From: Beggs, Tauren R - DNR
Sent: Wednesday, March 24, 2021 1:37 PM
To: Nicole L. LaPlant
Subject: RE: Jagemann Plating - BRRTS #02-36-555544

From: Nicole L. LaPlant <nlaplant@releeinc.com>
Sent: Thursday, March 18, 2021 12:06 PM
To: Beggs, Tauren R - DNR <Tauren.Beggs@wisconsin.gov>
Subject: Jagemann Plating - BRRTS #02-36-555544

JAGEMANN PLATING COMPANY
1324 S. 26TH STREET
MANITOWOC, WI
VAPOR INTRUSION MAP

FIGURE B.4.a

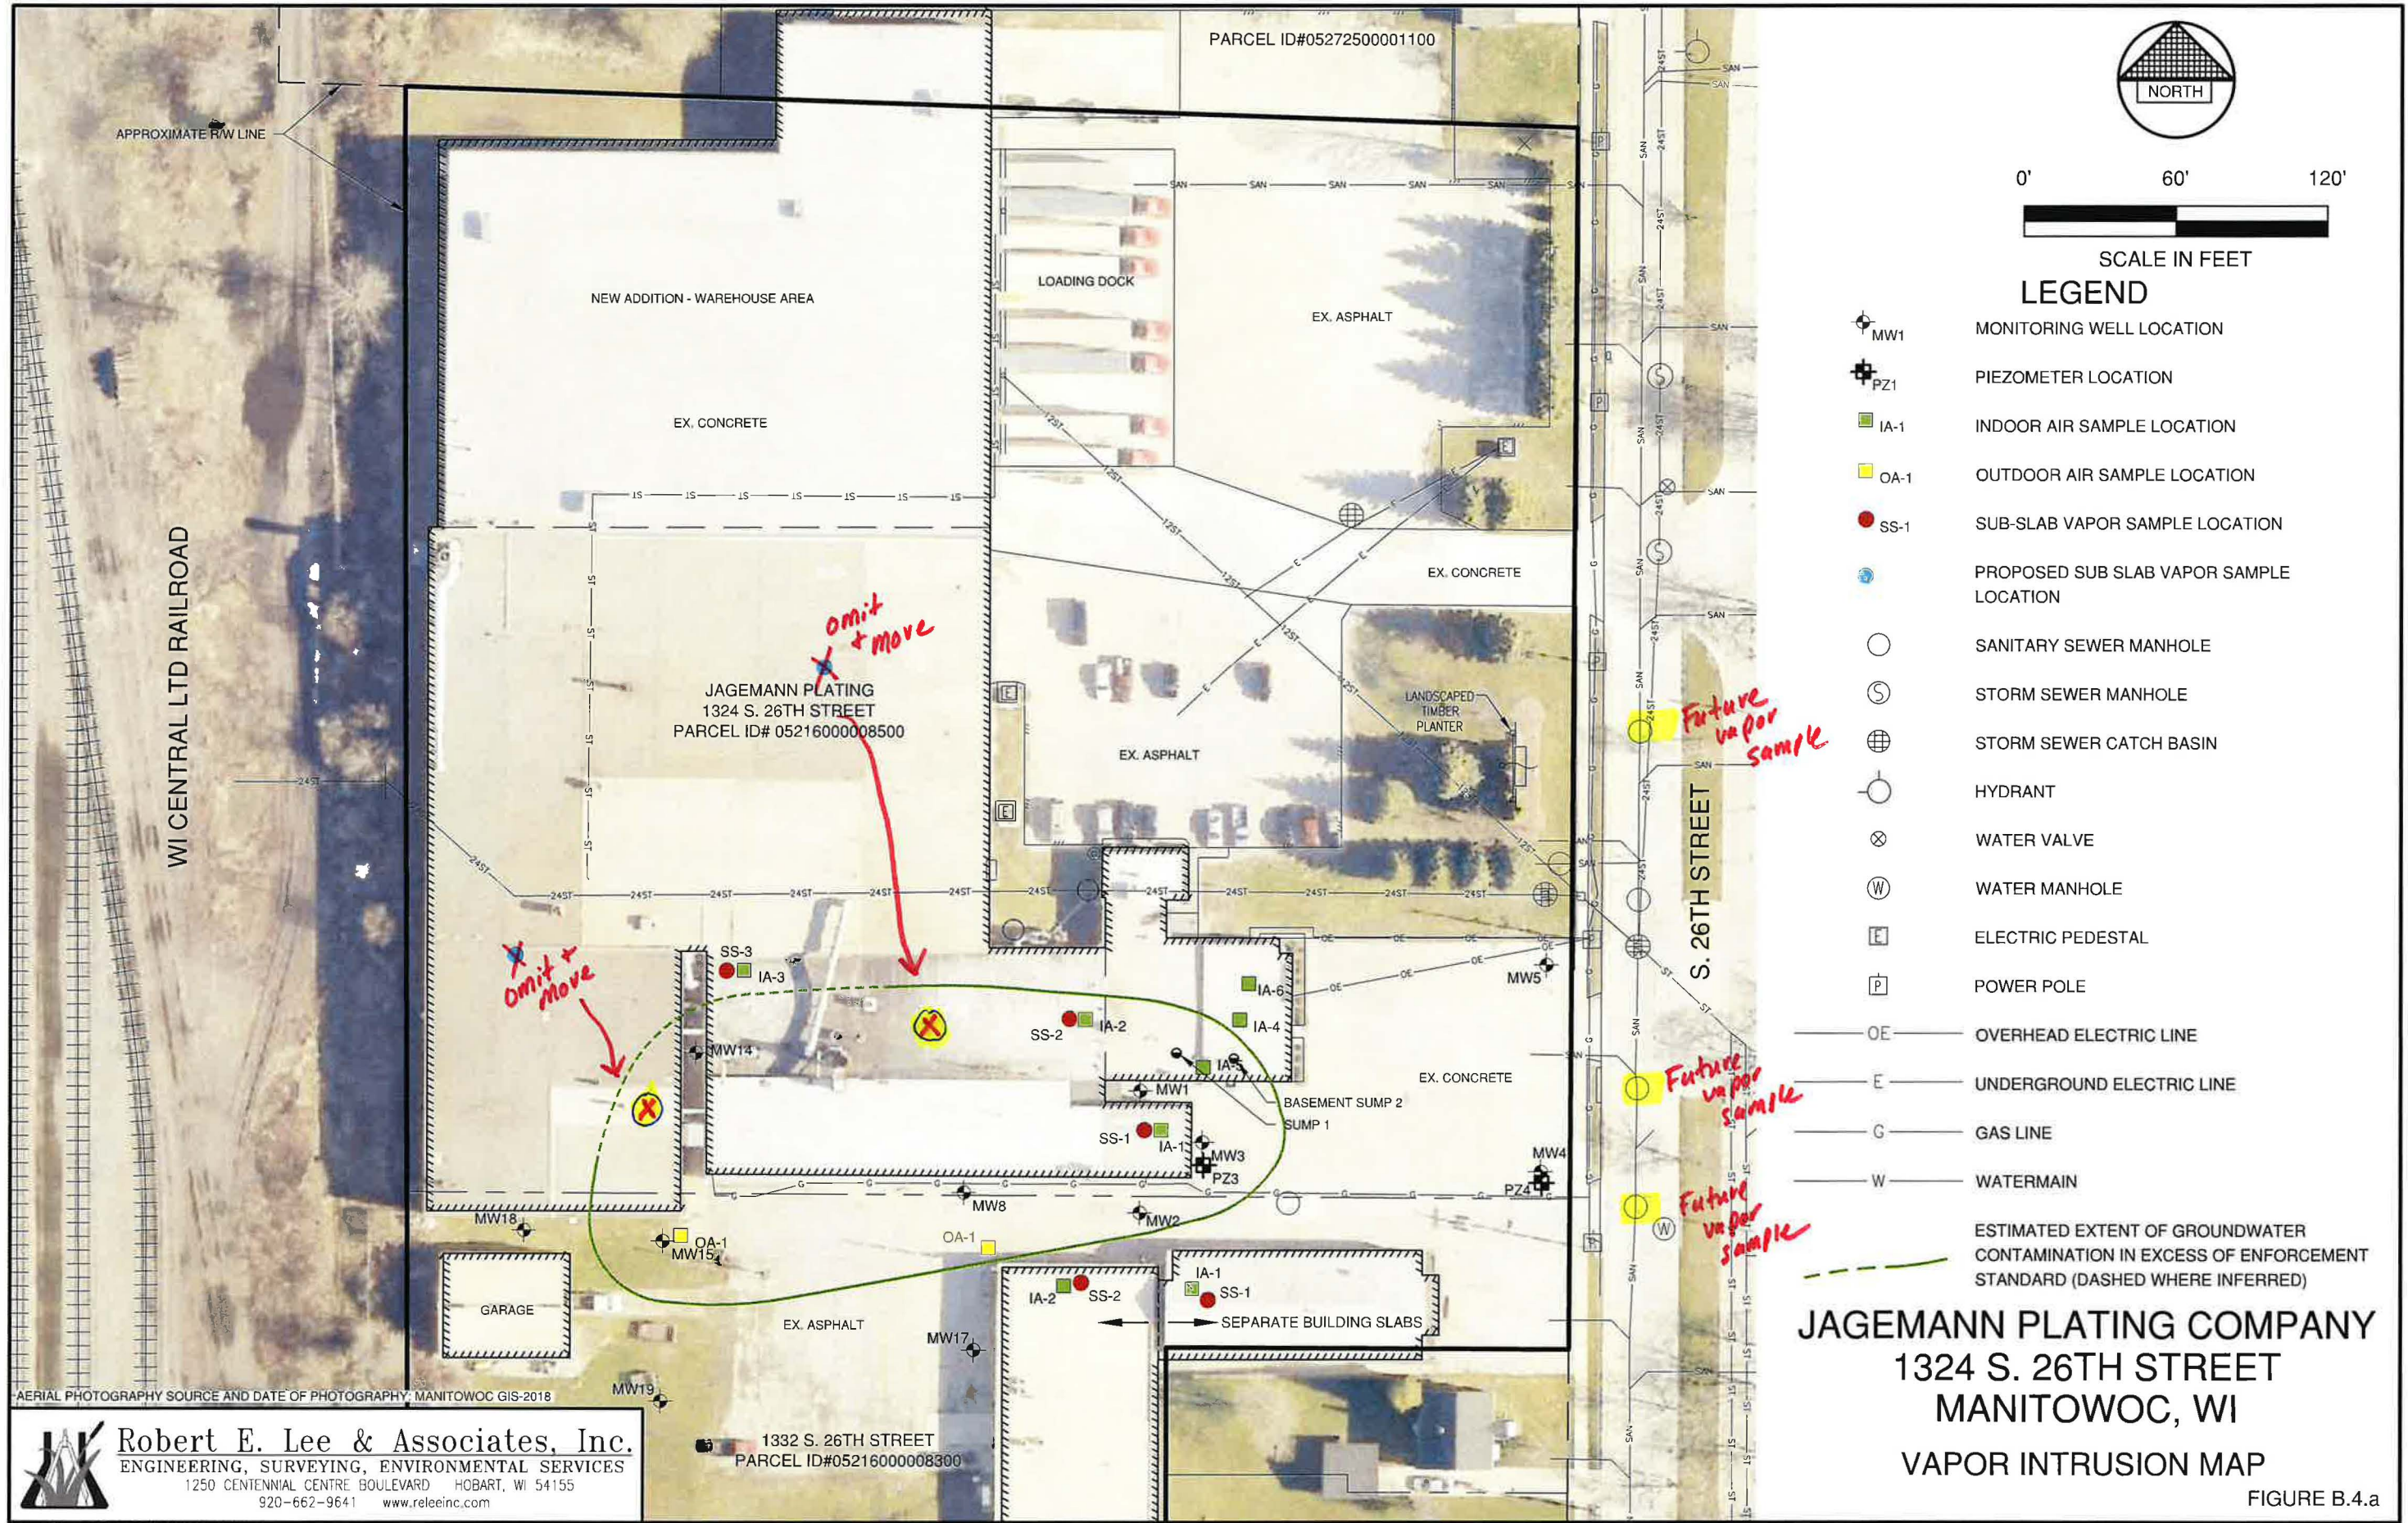
- The proposed new vapor pins should be moved within the southern portion of the building where the known groundwater contamination is located.
- The proposed sampling plan does not include an in-pipe sanitary sewer investigation to determine if vapor migration is occurring through the utility, so that will need to be completed.

(Note: I just noticed that the map has our sub-slabs labeled as an SS-x id. They should be labeled with an SSV-x instead.)

These revised locations look to be in much better locations for assessing the sub-slab vapors in the area of known VOC contamination. As we discussed, additional sub-slab locations may or may not be needed depending on the additional results received from the existing vapor pins and the new proposed vapor pin locations that are planned to be sampled as part of this upcoming work.

I received your comments. Thank you appreciate your comments. We will adjust the proposed vapor pin locations as discussed yesterday. I spoke with Mike today. We went over the ideal locations and that would work based on the set up of machines. The current proposed locations are on the attached map. The vapor sampling is still scheduled for March 27, 2021.
